APPLICATION FOR LAND USE CONSISTENCY DETERMINATION San Mateo County Airport Land Use Commission C/CAG ALUC

Project Name: The Crossings – Automobile Dealerships

Subject: Application for Land Use Consistency Determination for New Automobile Dealership at 1010 Admiral Court, San Bruno

Exhibit IV-17

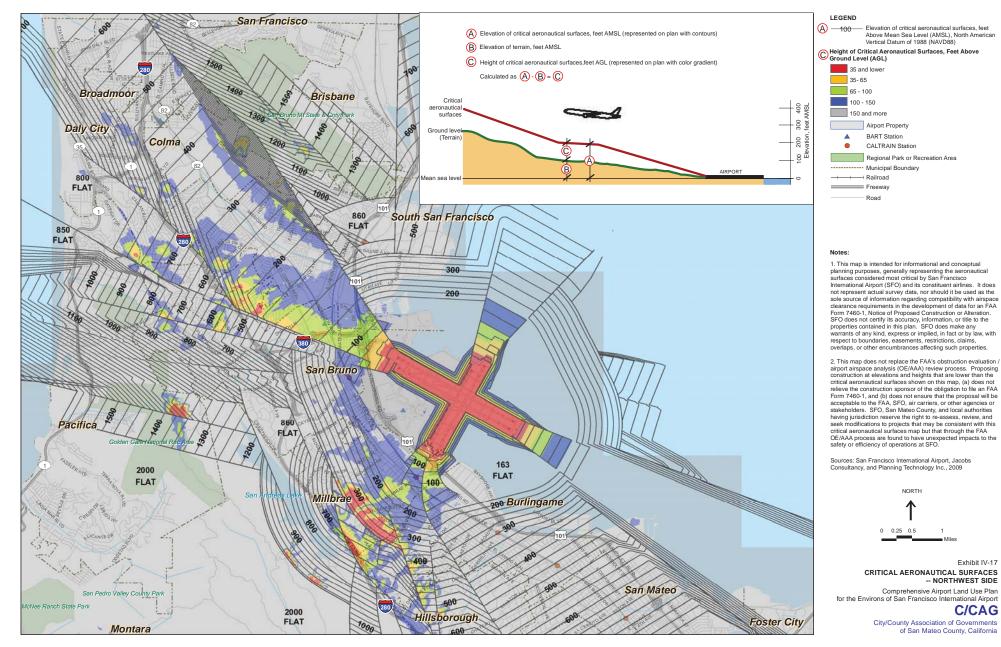
As depicted on Exhibit IV-17 of the SFO ALUCP (see Attachment), the lowest critical aeronautical surfaces above the Proposed Project are at an elevation of approximately 133 feet above mean sea level (AMSL) as defined from the origin of the North American Vertical Datum of 1988 (NAVD88). Given that the ground elevation at the Proposed Project site is around 67 feet AMSL (NAVD88), the maximum height of the building, as currently defined (at 50 feet above ground level or 117 feet AMSL), would be below the critical aeronautical surfaces and the Proposed Project would not appear to be incompatible with the Airspace Compatibility Policies of the SFO ALUCP, subject to the issuance of a "Determination of No Hazard" from the Federal Aviation Administration (FAA) for any proposed structures (see below), and determinations from the City/County Association of Governments of San Mateo County as the designated ALUC. The Airport notes that the applicant has been advised of the need to submit to the FAA the Form 7460-1, Notice of Proposed Construction or Alteration.
